PLANNING COMMISSION MEETING AGENDA

MAY 16, 2023

We have reviewed the Large-Scale Development Plans for Horse Barn 2. We have the following comments:

Re: Conditional Approval of Civil Plans
Janacek Remodeling Building 2022

SITE UTILITY PLAN

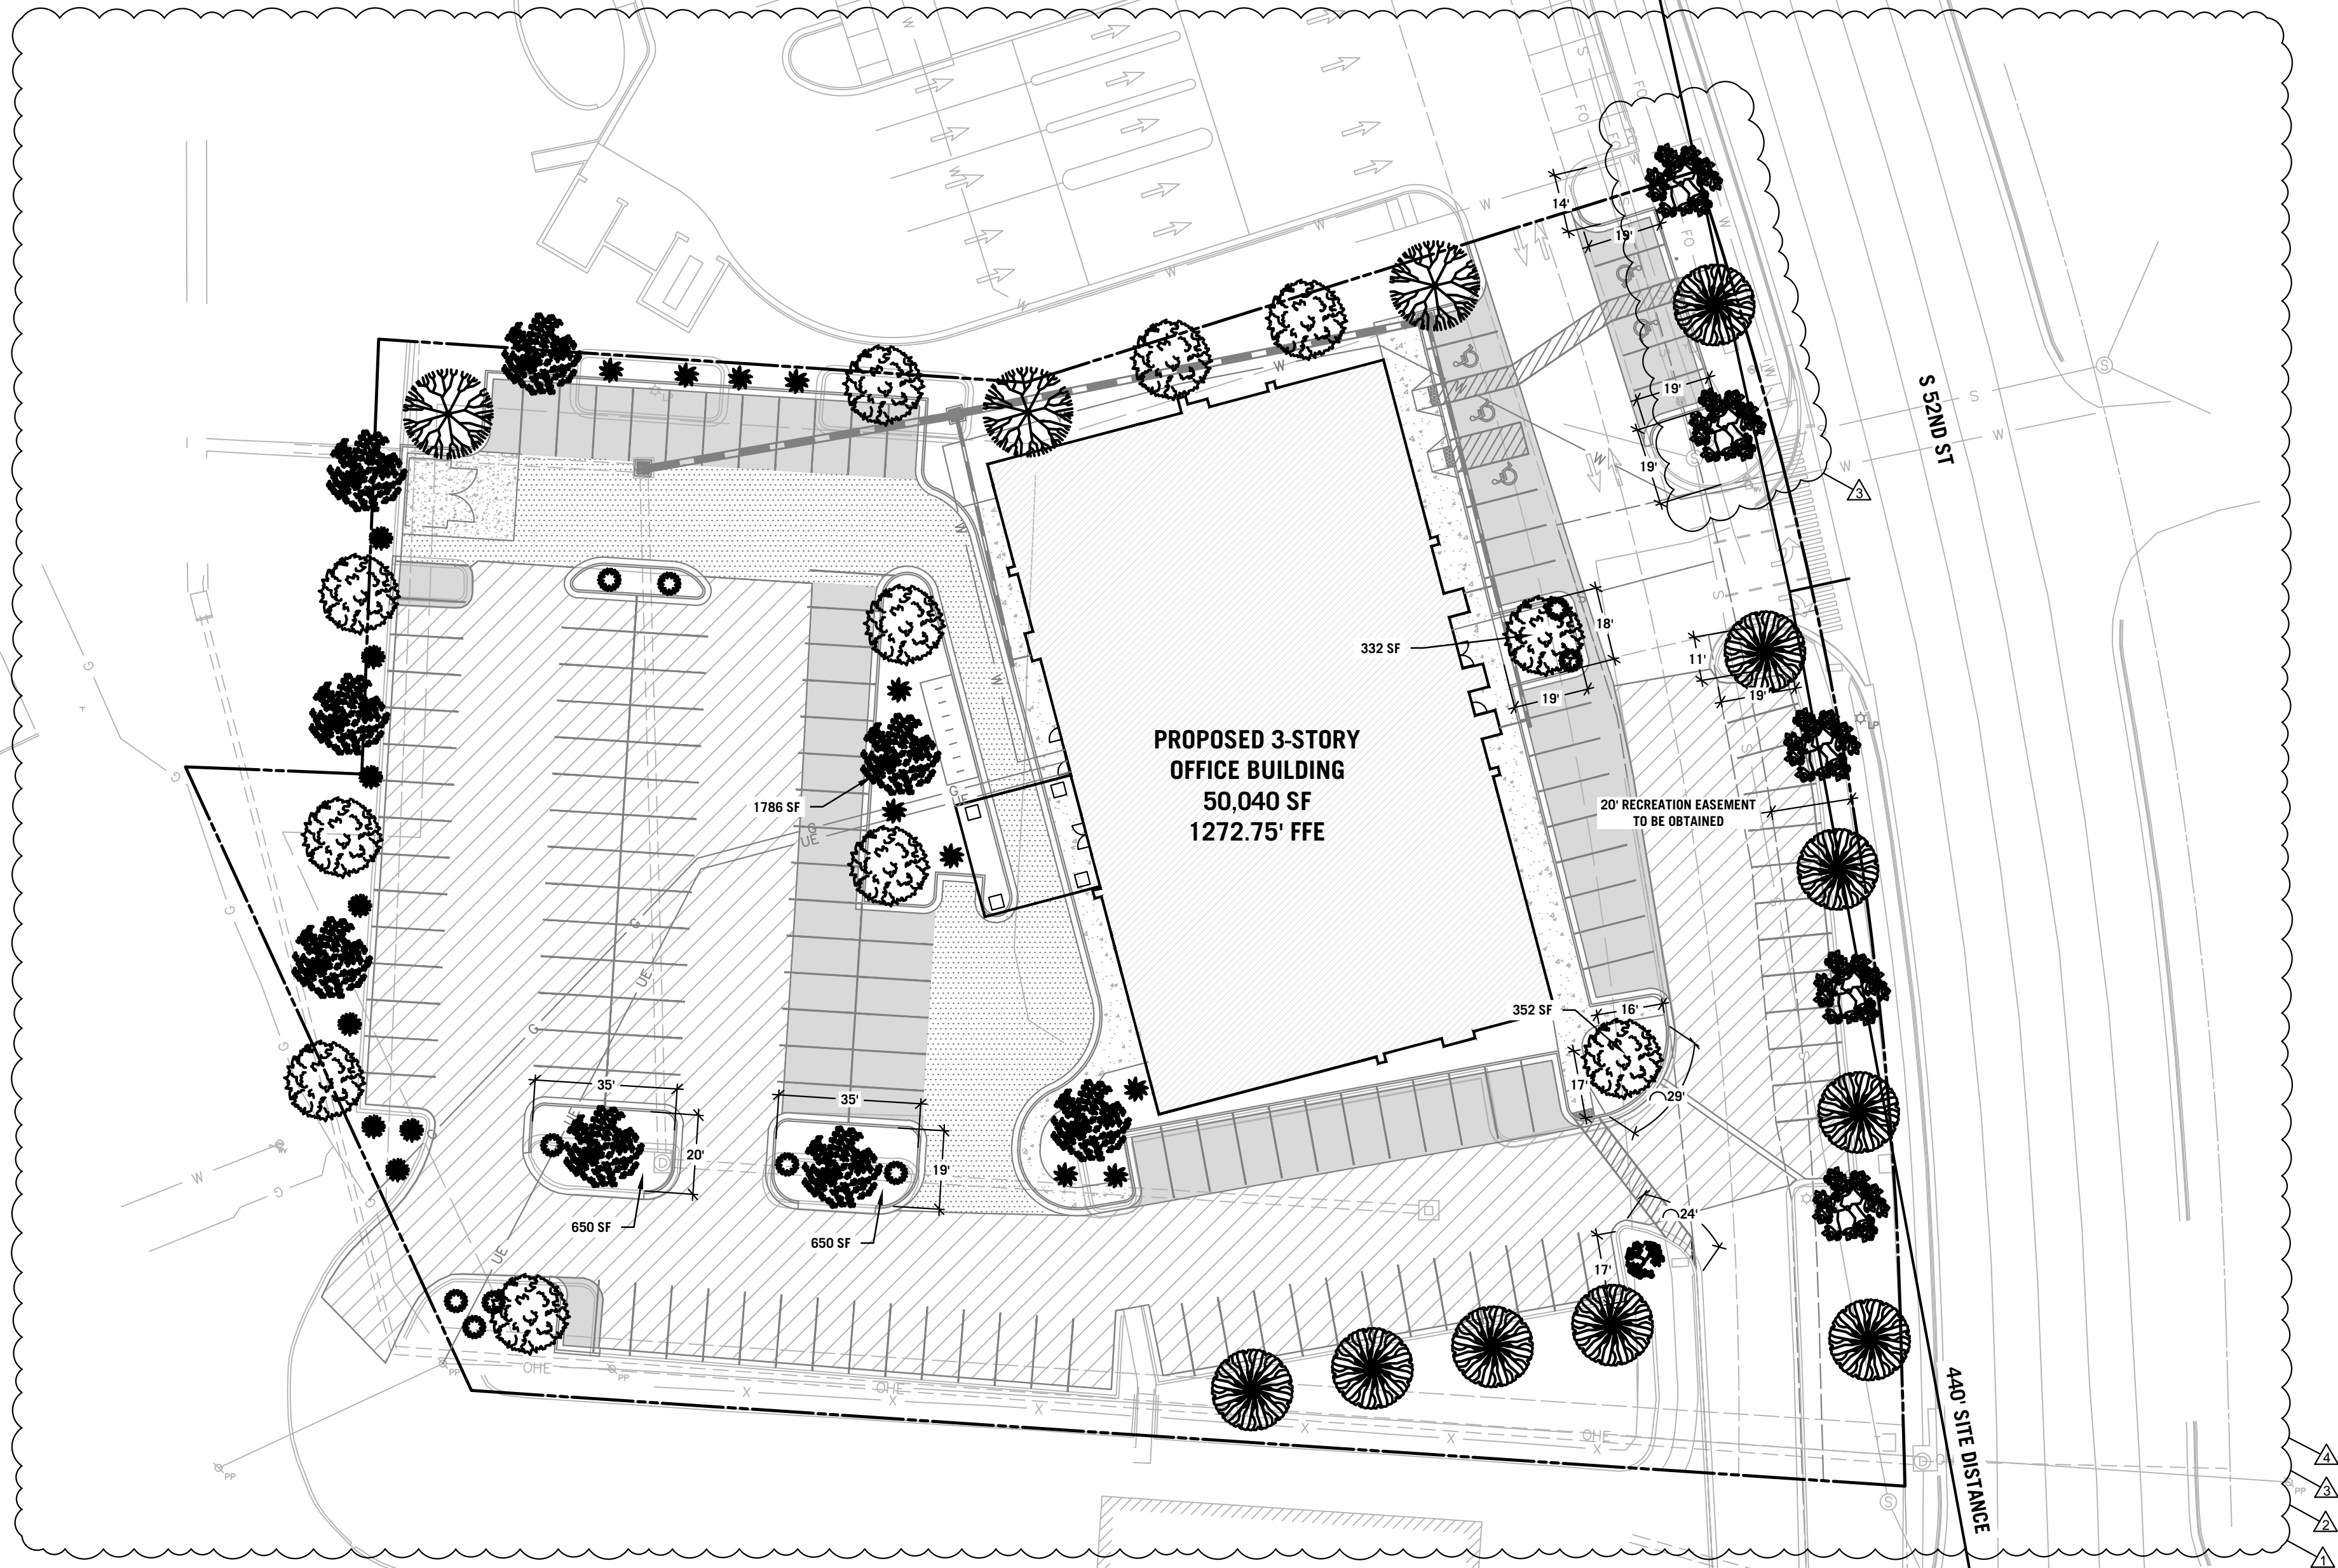
2. Depict the water and sewer improvements in this area for Armor Bank.
3. Identify the building 911 address on the plans.
4. Provide a profile of the fire line if required.
5. Show the existing water and sewer main sizes on the plans.
6. Show the location and size of the proposed water meter.
7. Show the location and size of a proposed irrigation meter and RPZA. Specify that a USC-FCCCHR approved RPZA will be required and located in a heated space or frost-free enclosure prior to any tees or branches for all irrigation service lines. (Provide a detail for installation indicating manufacturer, model number--complete with all suffixes and prefixes, size, and installation orientation must be shown).
8. When connecting a water service to an existing main note on the plans that RWU will construct the water meter service at the developer's expense.

9. The existing unused service line out of the manhole will need to be abandoned in accordance with RWU policy.
10. Show existing easements and their dimensions, along with book and page information.
(See the attached final plat.)

Revise the plans addressing each comment and submit one pdf copy of the revised plans **directly to this office** for final approval. Approval of this project is void if construction is not started within one year of the date affixed hereto.

DRAWN BY:	KAB
CHECKED BY:	JEI
DATE:	4/13/2022
JOB NUMBER:	20-1065
SHEET NAME:	UTILITY PLAN
File No:	20-1065.dwg
	C6.0

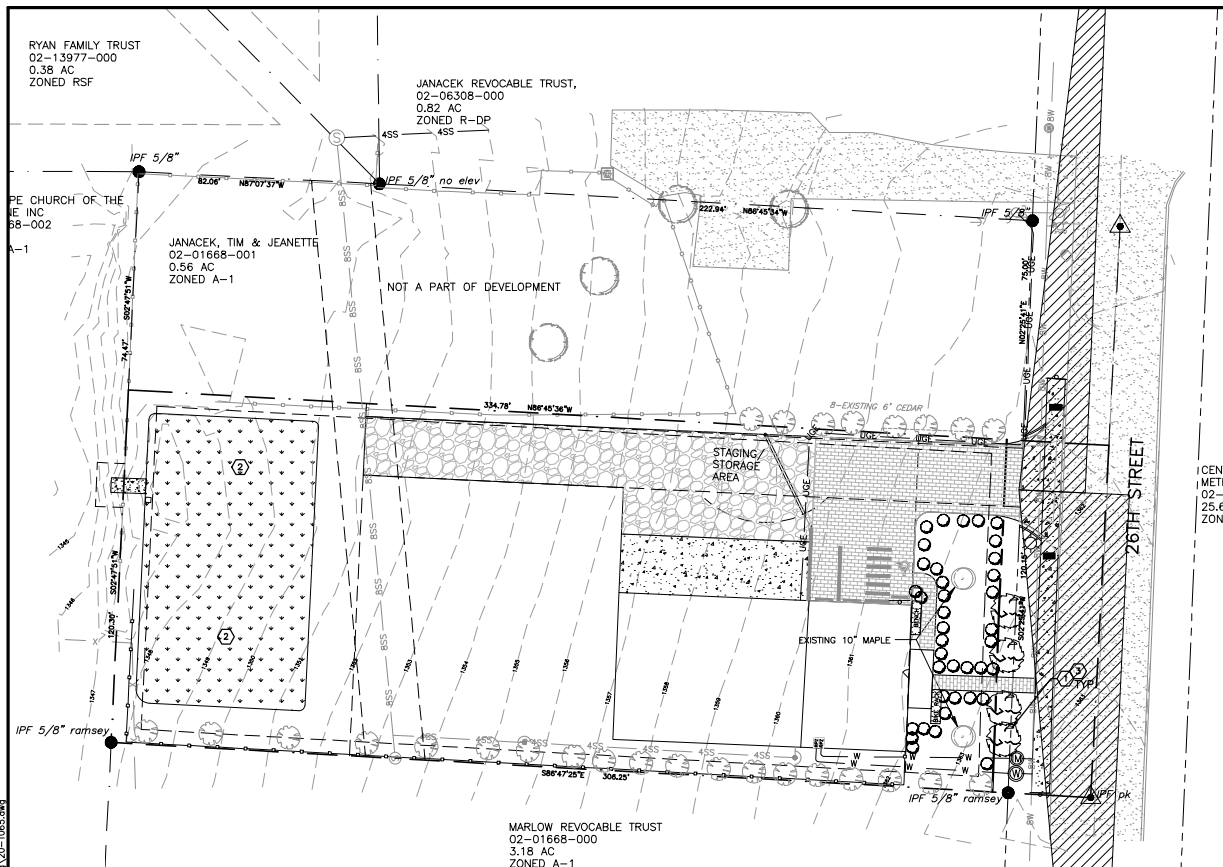
1. Increase the easement for the sewer to 20' due to the depths.
2. Revise the size noted for the SE inlet to the existing manhole, which still identifies it as a 4".

3. It appears that you are planning on two 5/8" meters, one for domestic and one for irrigation. Please clarify if this is not the case. You may want to consider specifying a double meter assembly if both are 5/8" to save money.

DRAWN BY:	JOHN	JOB NUMBER:	22-103
SUBMITTAL DATE:	05/03/2023	CITY NUMBER:	PL202200863
DRAWING NAME:	22-103 PR.DWG		
SHEET NUMBER:	C5.0

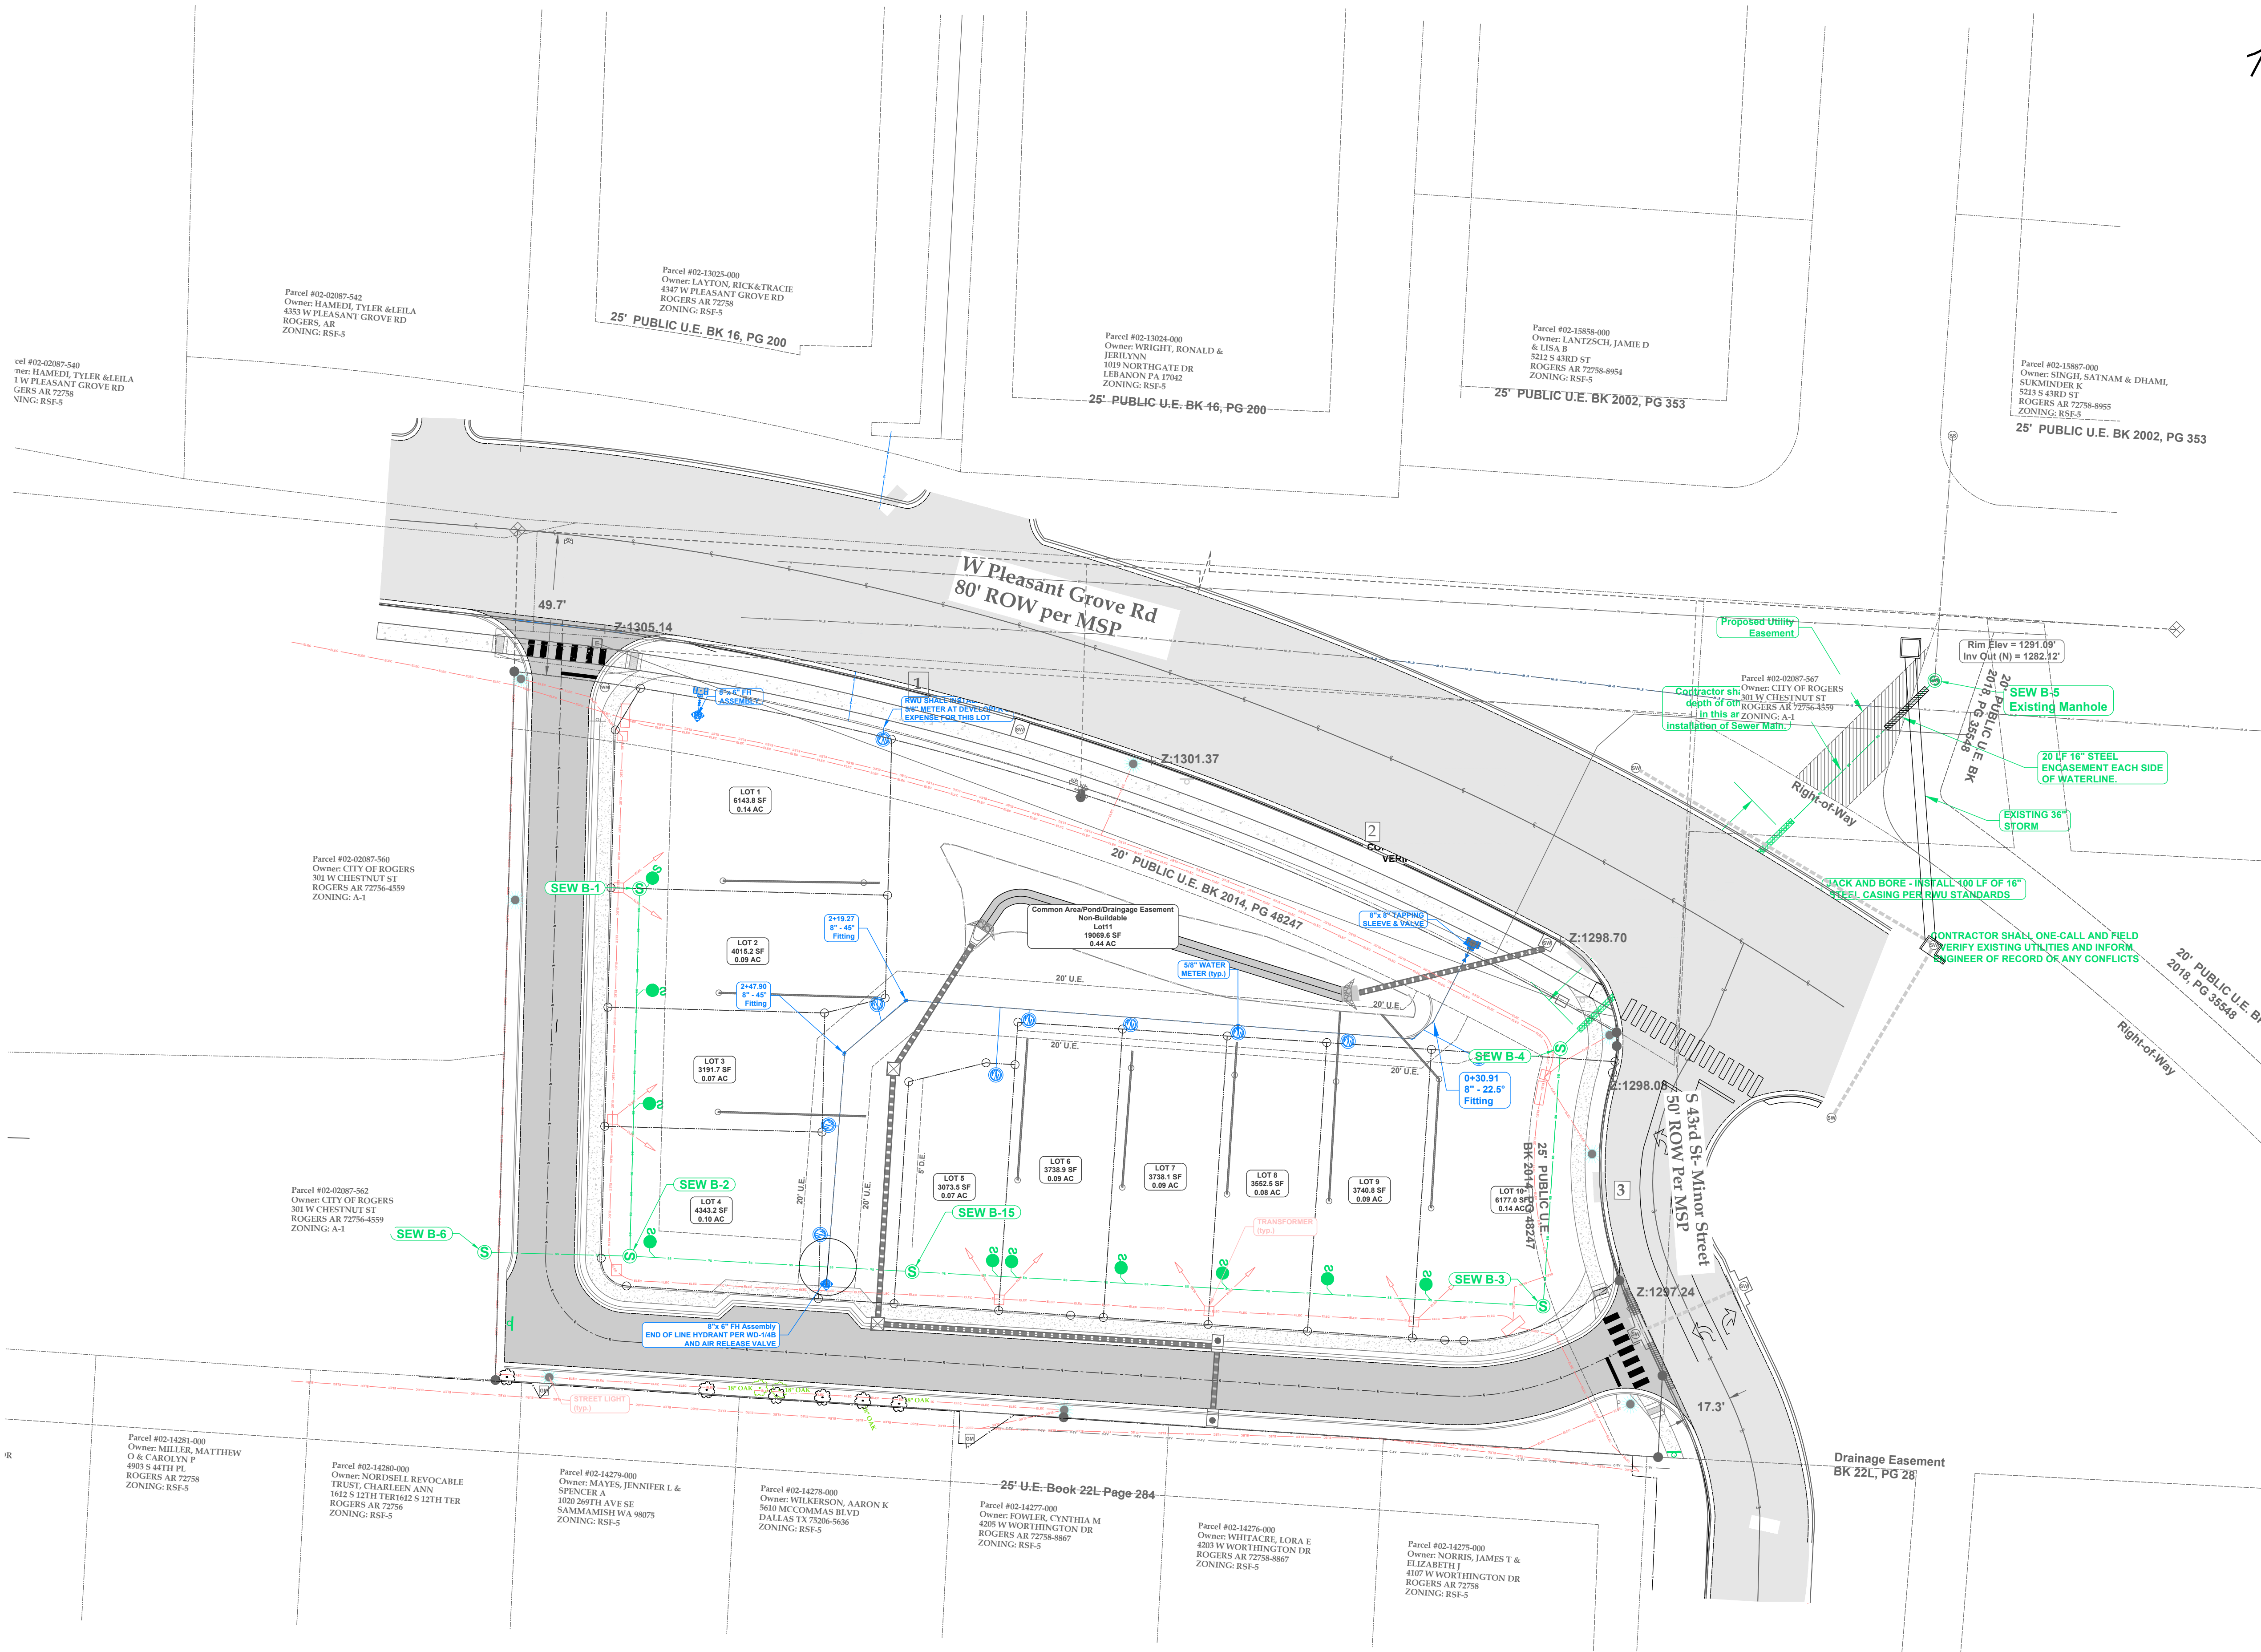
1. Remove the vertical bends and use pipe deflection instead. (See attached Sht. C5.1)
2. An AR Valve will be required at the high point on the water main.

5. Show encasement 10' on either side of the existing water main on the water main plan view. The 10' distance should be measured perpendicularly to the centerline of the existing water main.

6. Encasement is required for the sewer main since there is less than 18" of vertical separation between the water and sewer main.
7. Show the casing pipe invert elevations for the sanitary sewer main where it crosses the existing water main.
